STAFF REPORT
COMMUNITY DEVELOPMENT DEPARTMENT

HEARING DATE: 4/28/2022
 TO: Planning & Zoning Commission
 FROM: Joe Dodson, Associate Planner
 208-884-5533
 SUBJECT: H-2021-0070
 Burnside (Jackson) Ridge Estates
 Subdivision

LOCATION: The site is located near the southwest corner of S. Linder Road and W. Victory Road, including 2365 W. Victory Road, 3801 S. Linder Road, and parcels S1226142251, R0831430030, R0831430022, and R0831430010, in the NE ¼ of Section 26, Township 3N., Range 1W.

B. Preliminary Plat (dated: 2/3/2022) (NOT APPROVED)

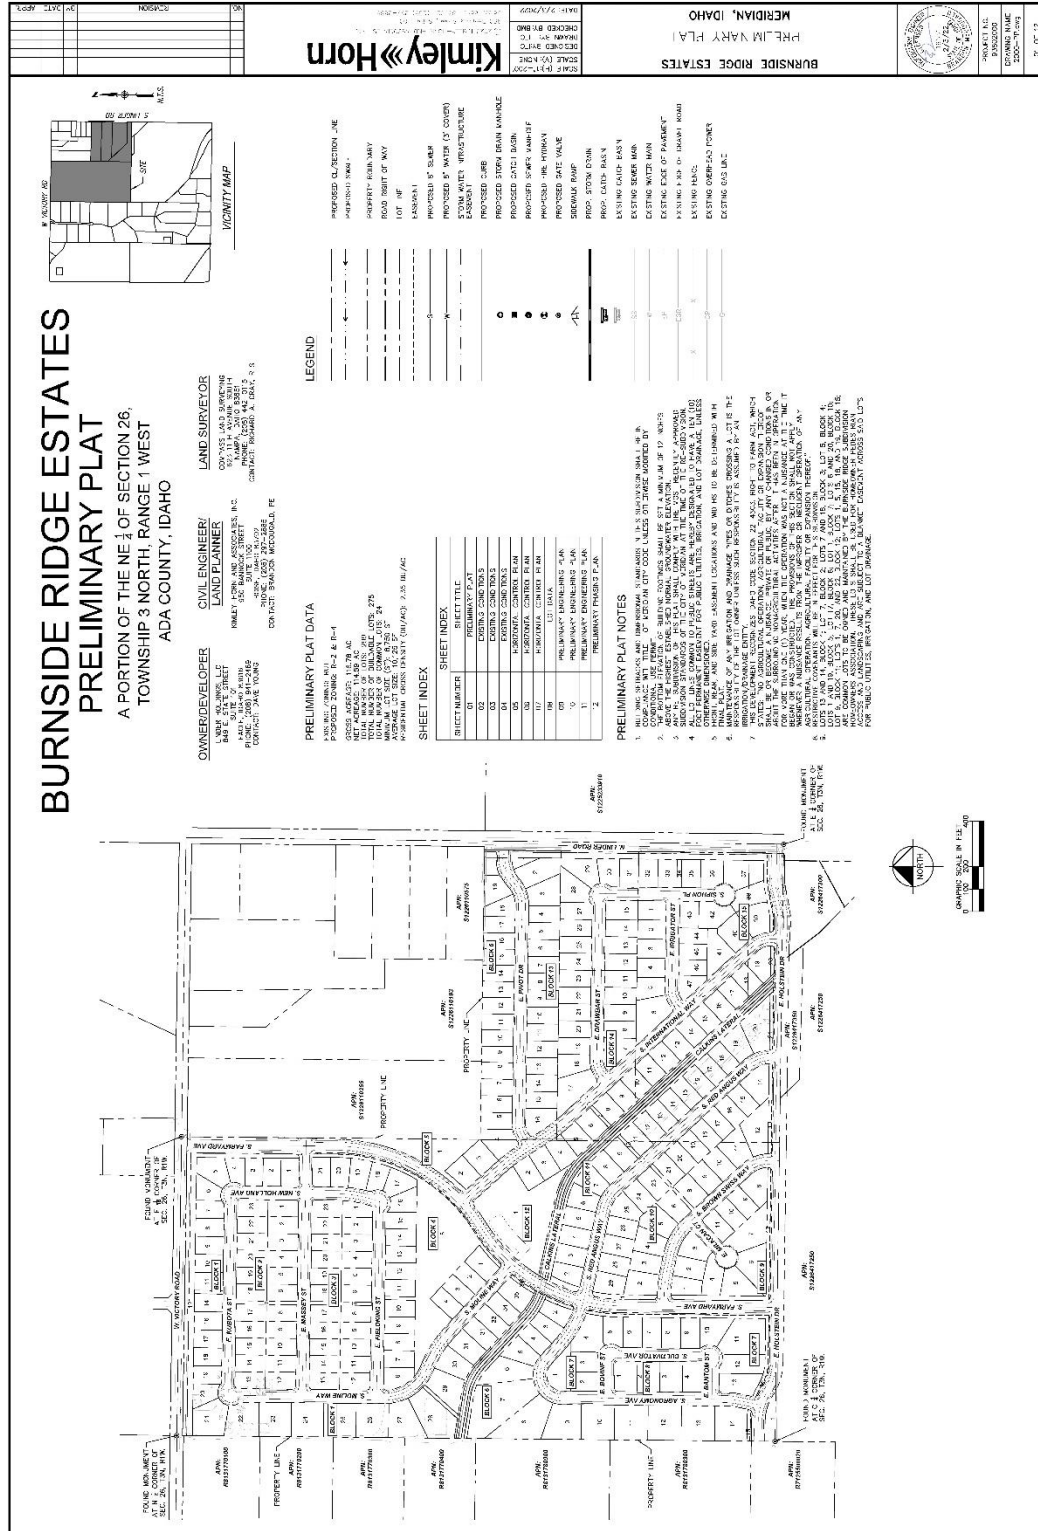
According to the submitted plat, the required collector street along the south boundary (E. Holstein Drive) is fully on the subject property at the east and west boundaries but curves down to be evenly split along the majority of the south property line. Specifically, this road is shown to be constructed with 18 feet of pavement from the property line to the back of curb on Burnside Ridge side of the property line. Typically, the first development in is required to construct their half of the street section (18 feet in this instance) plus 12 feet of pavement which would total 30 feet of pavement instead of the 18 feet proposed. This is important to note because this segment of road is adjacent to a County parcel that is not part of the subject annexation request and may require the road to shift 12 feet north to accommodate the additional ROW if ACHD does not accept this road segment as proposed.

Lastly, the subject development abuts a number of county parcels to its northeast and the Applicant has proposed to stub a street to their shared property line near the northeast corner of the site (east side of Farmyard Avenue). Because of the number of parcels adjacent to this project, Staff recommends an additional stub street be added to the north property boundary from E. Pivot Drive in the southeast third of the project to help create better opportunity for interconnectivity in the future. Specifically, Staff is recommending this stub street be located approximately in the area of Lot 11 or 12, Block 5.

E. Pivot Drive along the north boundary in the southeast quadrant is approximately 1,200 linear feet with no breaks in the block length. To correct this, Staff recommends an additional stub street is stubbed to the north boundary near Lot 11 & Lot 12, Block 5 for future connectivity and to break up this block length consistent with UDC provisions. Further, Staff recommends an additional 15-foot wide micro-path lot is added to the south side of E. Pivot in line with the recommended stub street location to head south between pivot and E. Drawbar to provide a more convenient pedestrian access through this area of the site.

*Lastly, S. Red Angus Way is a local street that goes at a diagonal angle to the arterial streets in the south half of the development and is approximately 1,400 feet in length with a micro-path connection near mid-block. However, UDC 11-6C-3F specifically limits the maximum block length allowed to 1,200 feet regardless of a pedestrian connection without site constraints; this code section also outright prohibits any block length greater than 1,200 feet without obtaining a City Council waiver. **Because the proposed block length is greater 1,200 feet, Staff recommends the Applicant provide an additional cross street from Red Angus northeast to S. International Way across the Calkins Lateral in alignment with E. Drawbar Street to create a compliant block length. Furthermore, this new cross street would also provide better interconnectivity within the site and better access to the multi-use pathway along the Calkins Lateral. Staff finds this solution favorable to a Council waiver.***

In addition to block lengths, UDC 11-6C-3 discusses double fronted homes and prohibits this type of lot configuration unless unusual topography or other conditions make it impossible to meet this requirement; no such circumstances exist for this development so the Applicant must comply with this requirement. Lots 1-4, Block 8 are depicted as having frontage on both S. Agronomy and S. Cultivator which does not comply with this section of code. In order to comply with the UDC, the Applicant should attach the sidewalk and include a minimum 10-foot wide common lot measured from the back of sidewalk to the rear property line adjacent to one of these local streets; Staff does not have a preference as to which street has the common lot added.

2. The preliminary plat included in Section VII.B, dated February 3, 2022, shall be revised as follows at least fifteen (15) days prior to the City Council hearing:
 - a. Revise Blocks 2 & 3 to include R-8 compliant lots and add additional building lots to comply with the minimum gross density requirements west of S. Farmyard Avenue (at least 2.5 du/ac).

- c. Add an additional stub street to the north boundary near Lot 11 or Lot 12, Block 5 for future connectivity and to break up the block length of E. Pivot Drive.

- d. Add an additional cross street from S. Red Angus Way heading northeast to S. International Way across the Calkins Lateral in alignment with E. Drawbar Street to create a compliant block length, provide better interconnectivity, and provide an additional access to the multi-use pathway along the Calkins Lateral.

- e. Attach the sidewalk and include a minimum 10-foot wide common lot measured from the back of sidewalk to the rear property line adjacent to one of the local streets abutting Lots 1-4, Block 8 to remove the double frontage on these lots.

- f. Add the following additional micro-path lots at least 15 feet in width with a 5-foot wide pathway: 1) south side of E. Pivot in line with the recommended stub street location to head south between pivot and E. Drawbar and; 2) along the west boundary from S. Agronomy Avenue to the west property line near the shared property line of Lots 10 & 11, Block 6.

- g. Depict the correct width of the Calkins Lateral easement and depict whether any buildable lots are encumbered by said easement.
3. The landscape plan included in Section VII.D, dated January 31, 2022, shall be revised as follows at least fifteen (15) days prior to the City Council hearing:

D. Landscape Plans (dated: 1/31/2022) (NOT APPROVED)

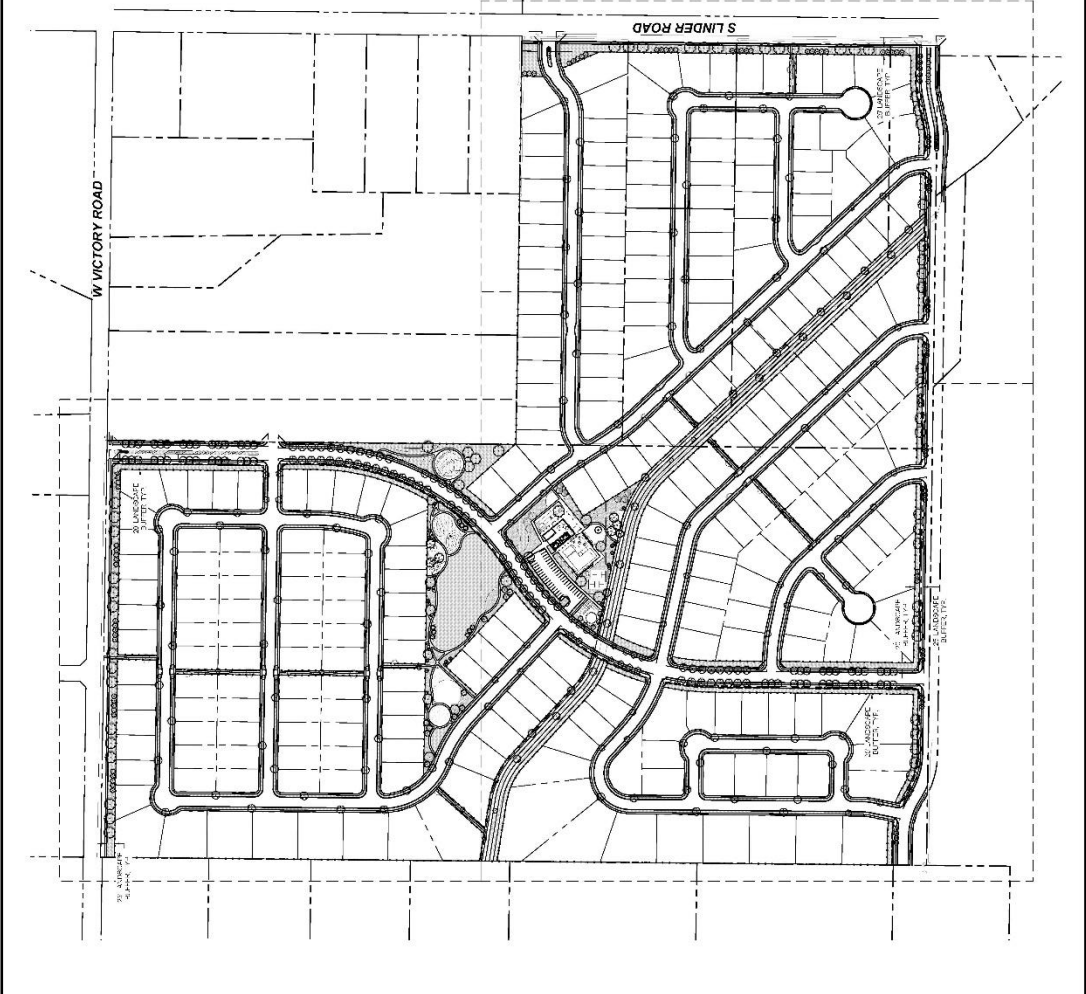
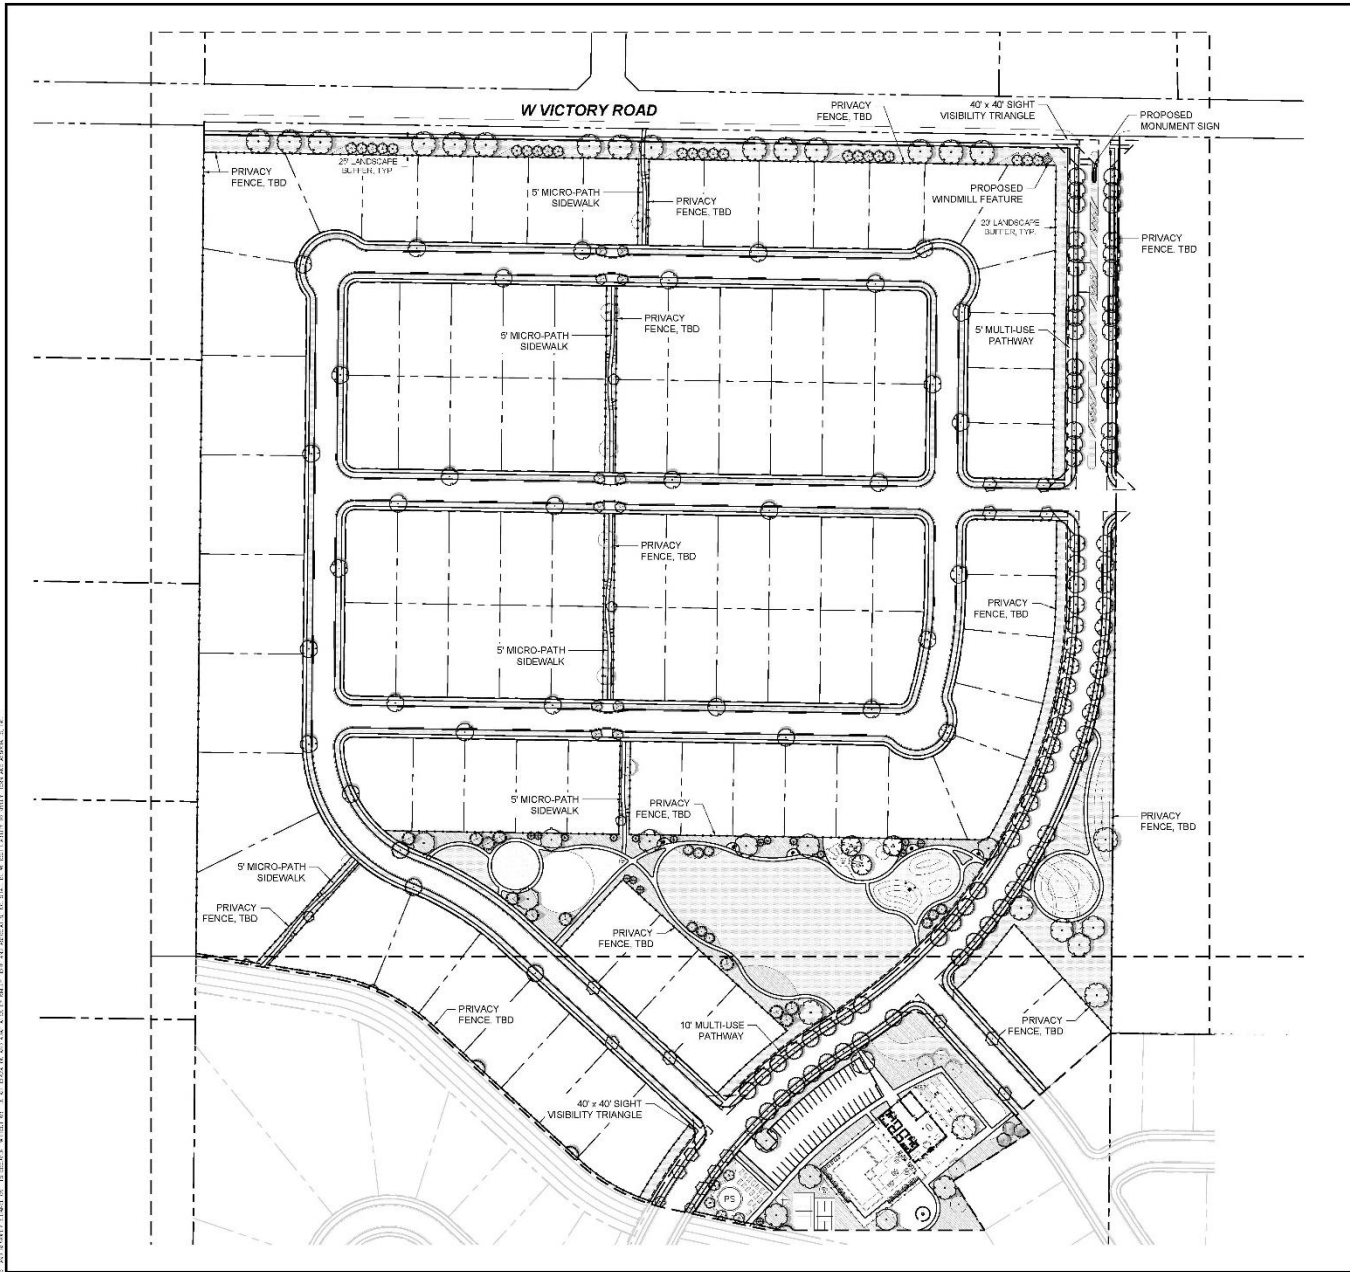
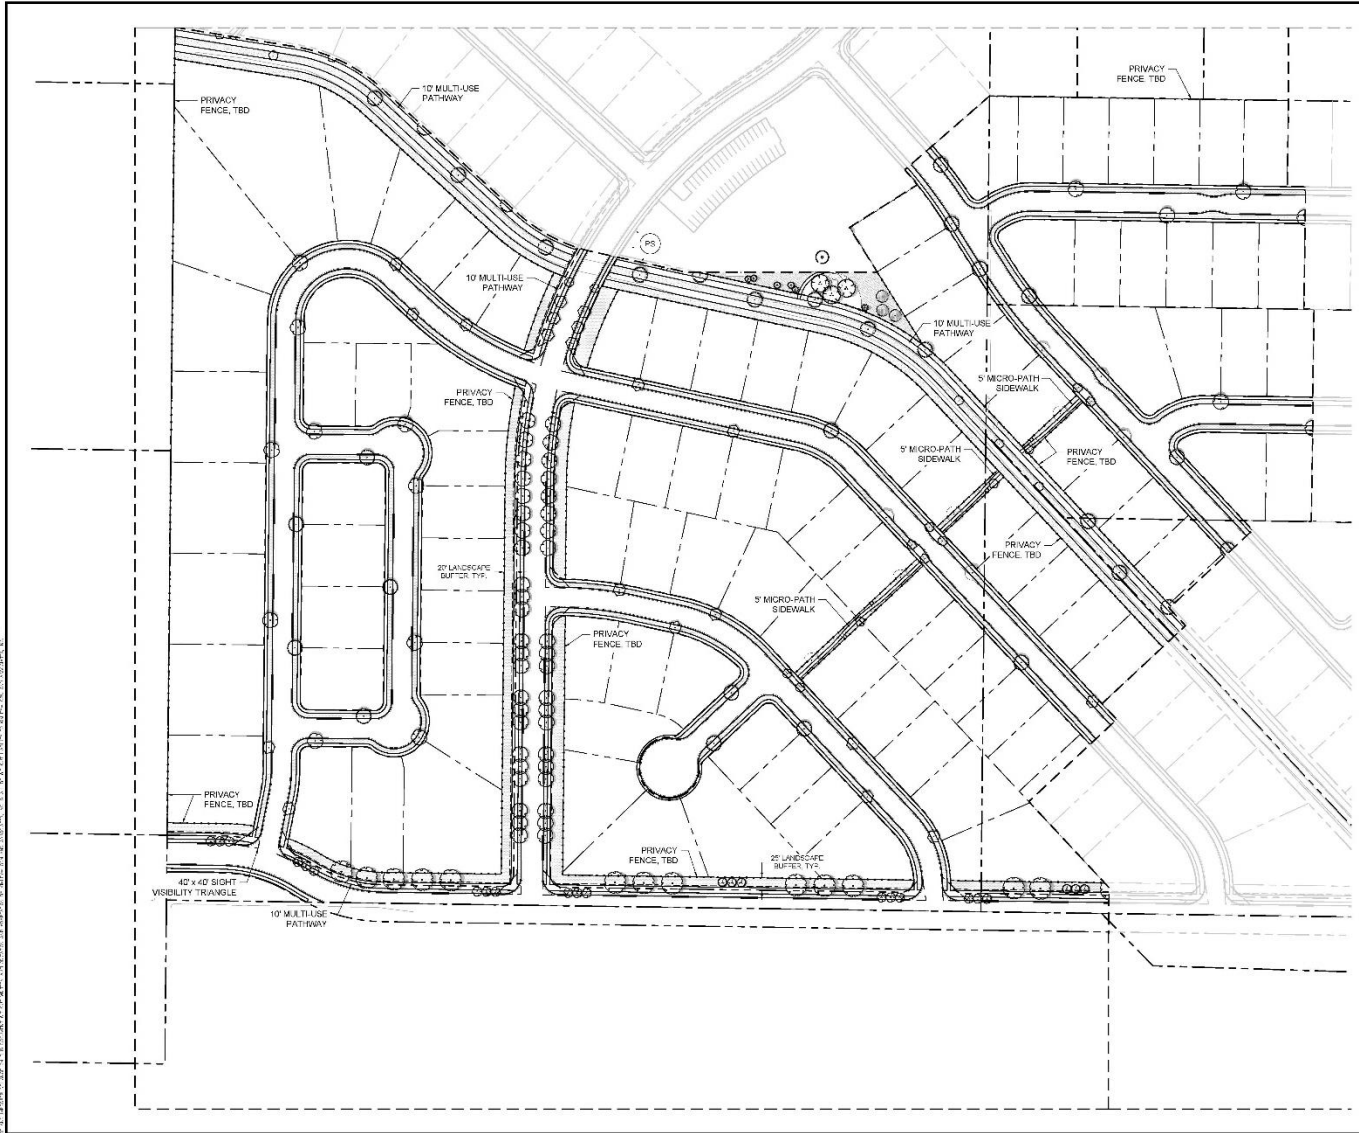
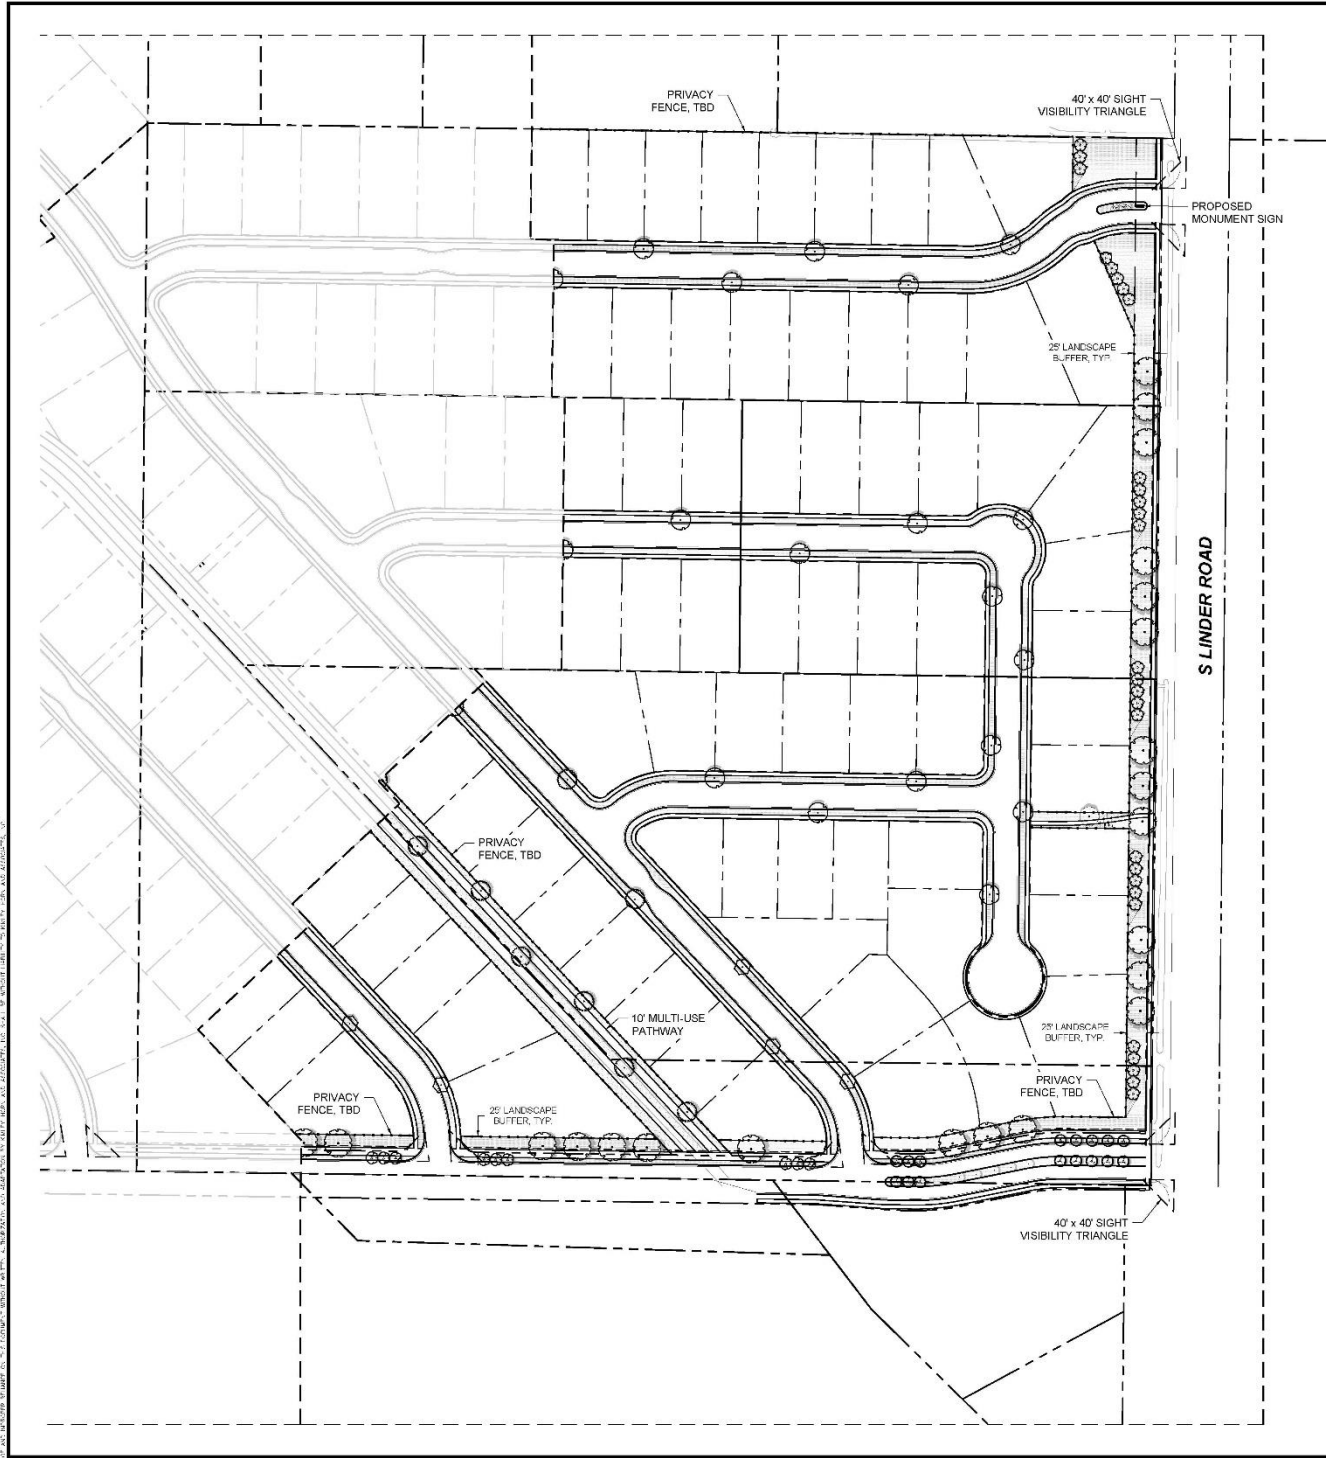
8-foot wide parkways with street trees are shown along all local streets within the development and are required to be landscaped per the standards listed in UDC 11-3B-7C. According to the submitted landscape plan, the correct number of trees ***are not*** shown and the table does not list the parkways at all. *Prior to City Council, the Applicant should correct this by adding the correct number of trees (1 per 35 linear feet) and list the linear feet of parkway within the landscape table and show the correct number trees per the provisions outlined in UDC 11-3B-7C.*

Common open space is required to be landscaped in accord with the old standards listed in UDC 11-3G-3E. The total square footage of common open space and the required number of trees to demonstrate compliance with UDC standards is not included in the Landscape Calculations table but the submitted plans appear to show UDC compliance. *Prior to City Council, the Landscape Calculations table should be corrected to include this requirement and reference the requirement of 1 tree/8,000 square feet of common open space.*

- a. Revise the landscape plans to match the revised preliminary plat as detailed above;
 - b. Per UDC 11-3B-7C, depict the correct number of trees (1 per 35 linear feet) within the proposed parkways and list the linear feet of parkway within the landscape calculations table.

- d. Replace a lot in each of the two southern quadrants (southwest third and southeast third) with an additional open space lot—Staff recommends Lot 21 or 22, Block 13 in the southeast third and Lot 7 or 8, Block 7 in the southwest third.

- e. Per UDC 11-3A-6C, depict 6-foot tall open vision fencing along both sides of the Calkins Lateral.
 - f. Remove the micro-path common lots of Lot 7, Block 12 & Lot 10, Block 11 in lieu of the recommended new cross street noted in VIII.A.2d.

- g. Depict the proposed type of fencing on a sheet within the landscape plans to ensure compliance with development code.
4. The Applicant shall revise the open space exhibit to match the revised plat and landscape plans and include the eligible parkway area per the provisions in UDC 11-3G-3B.4.
